Introduction: Project Background

EDG 6 June 2012

Summary of Priorities & Board Recommendations

5. North façade on Mercer St.:

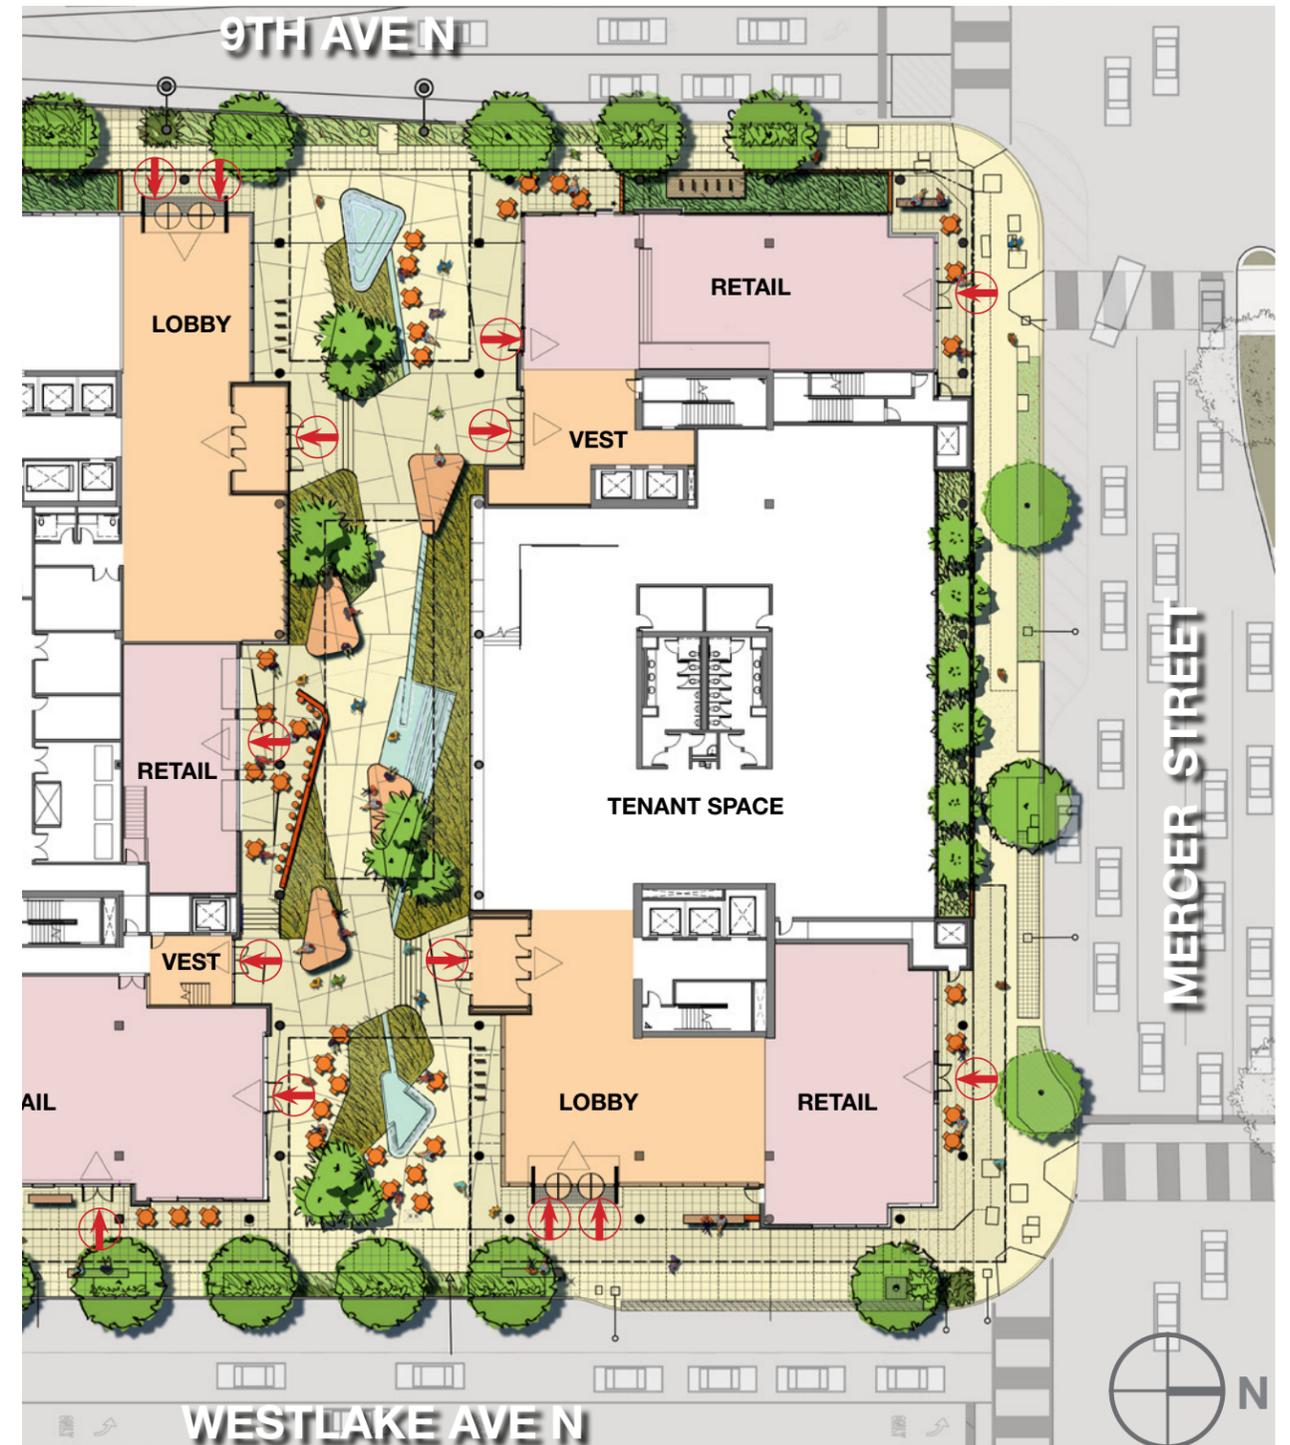
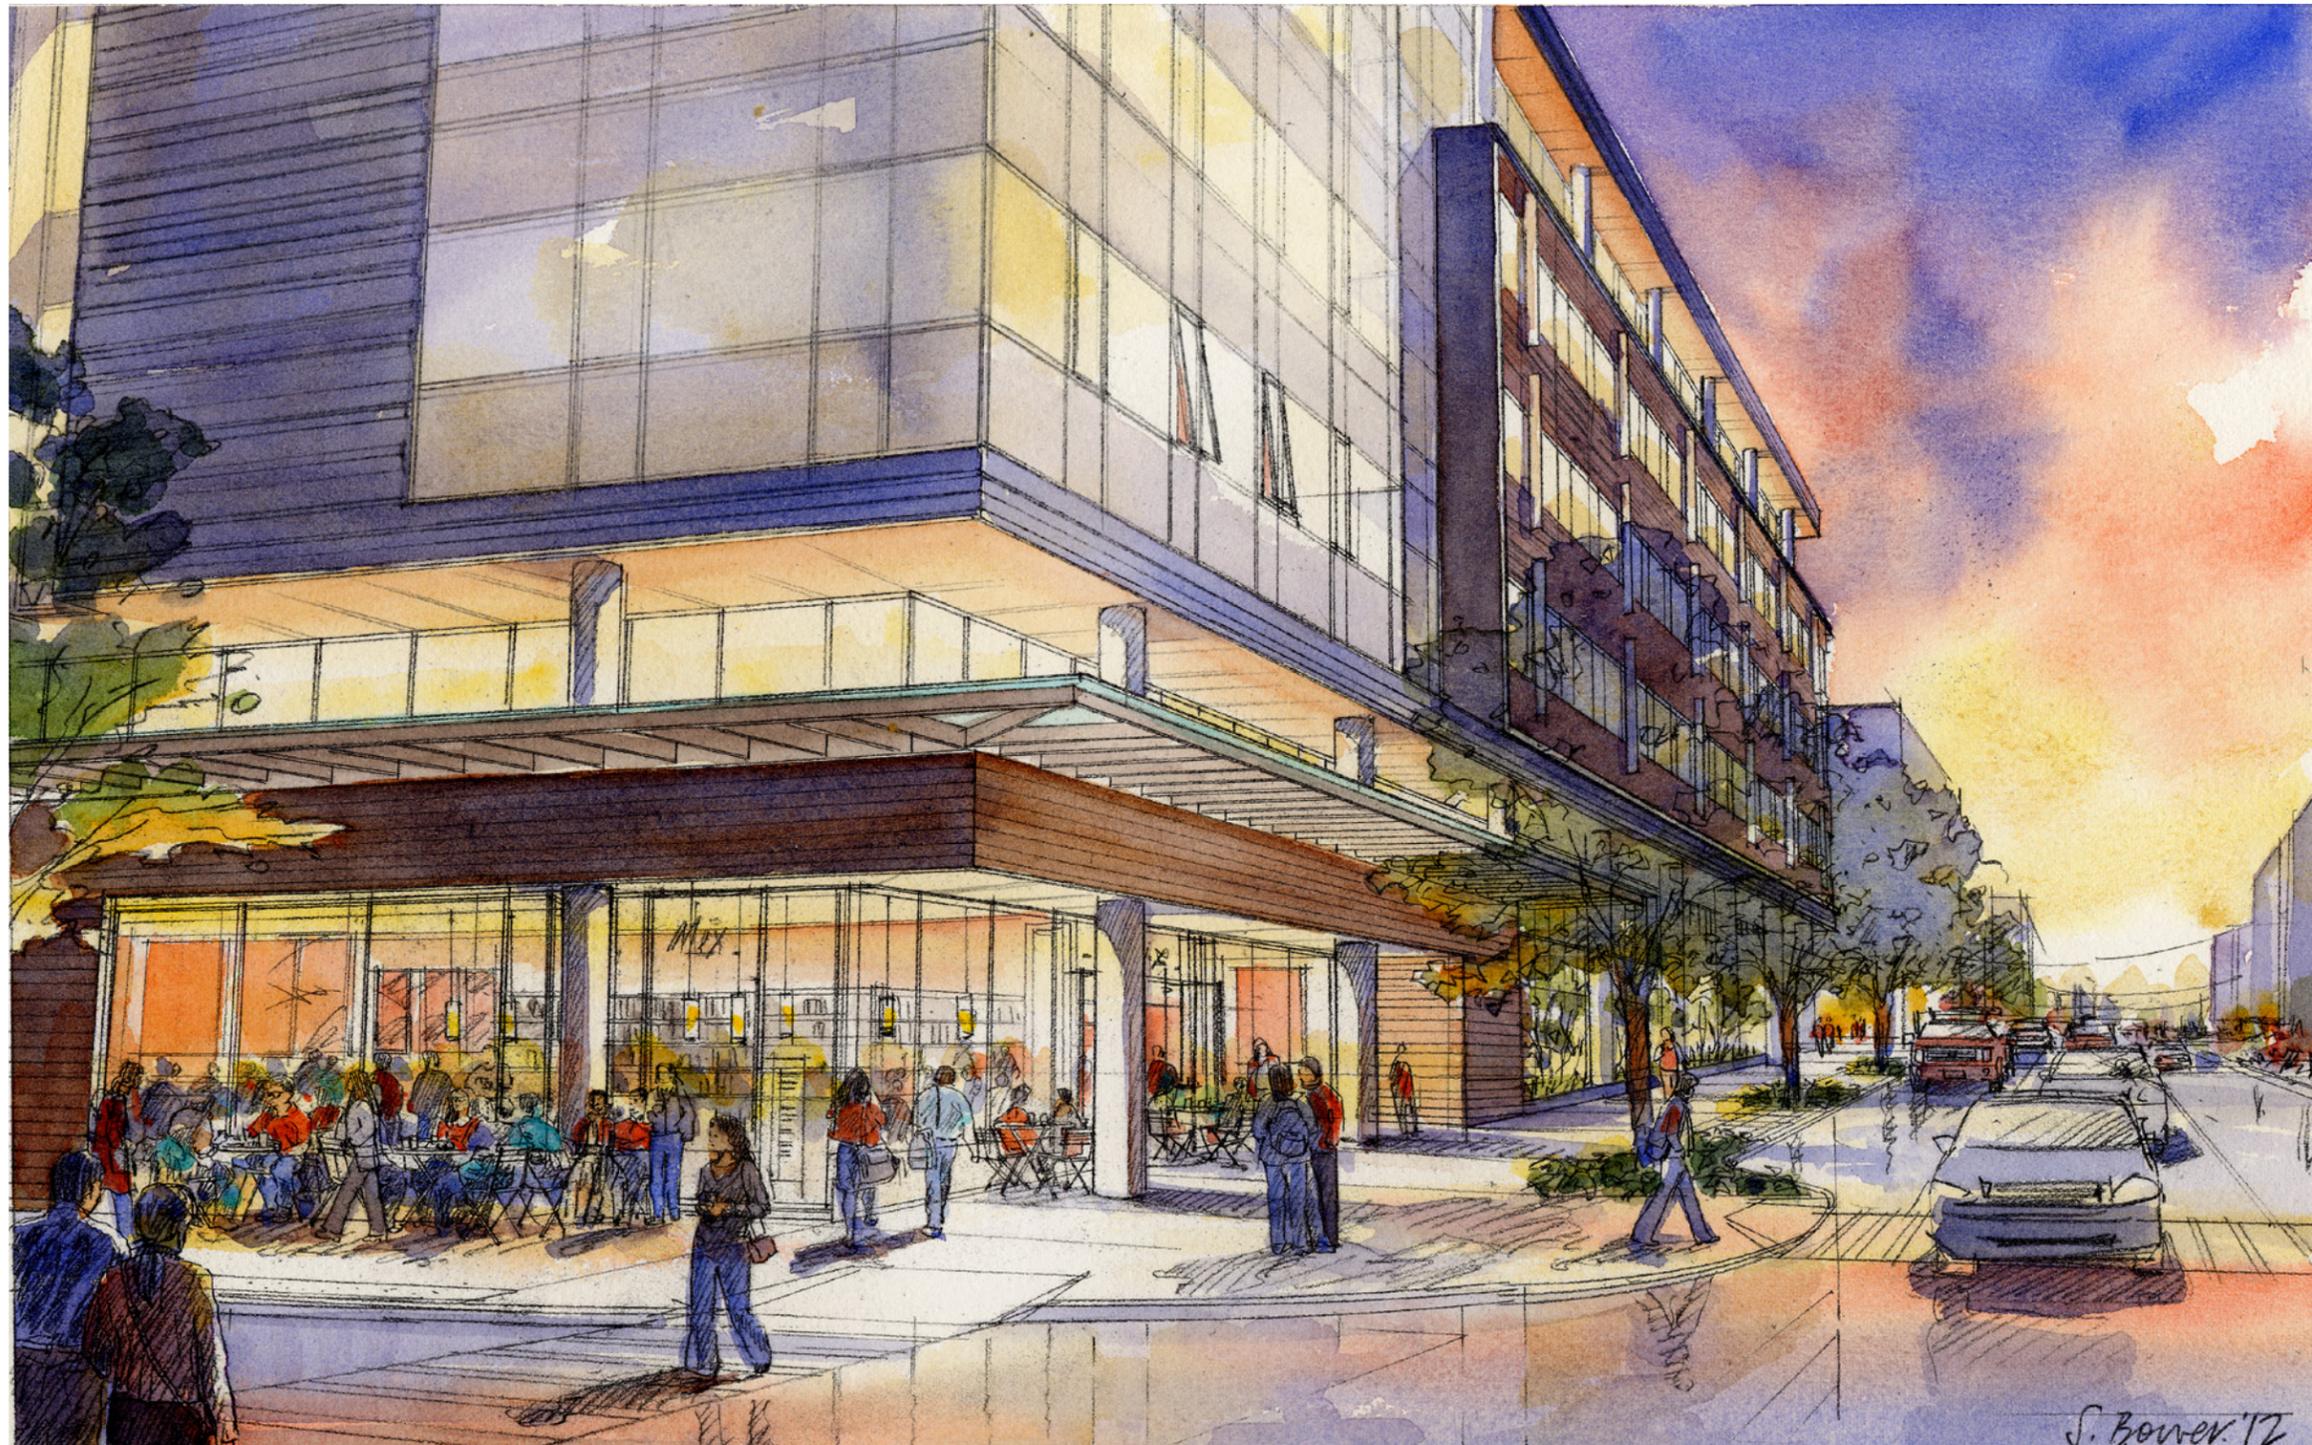
- The building is blocky; the design should include shaping of the mass. Setting back the ground floor may help, as well as articulation, and shaping of the corners. Focus on the pedestrian perspective.

- The Board noted this façade appears potentially problematic, due to the retail entries fronting on the pedestrian connection and the building turning its back on Mercer St. (A-3, D-1)
- The Mercer St façade should include a visible major pedestrian entry. (A-3, D-1)
- The use at that façade of meeting rooms is also potentially problematic, since these spaces are often unoccupied. The applicant should demonstrate how the street level facades will encourage an activated street frontage on Mercer St. (A-4)
- The design of this façade needs to include significant design moves to break down the appearance of the long façade and to create human scale. (B-1, A-4, C-3)

Mercer Street is a major urban connector with a large-scale high traffic function (60,000 cars per day). To enhance pedestrian vitality, the project has added retail at the northeast and northwest corners and provided points of access at both retail spots. Due to the slope of the site, and the desire for building lobby entry on Westlake, the mid-block zone is set back to create a landscape design opportunity, providing scale and varied texture, in a block that is without the Mercer boulevard median landscaping.
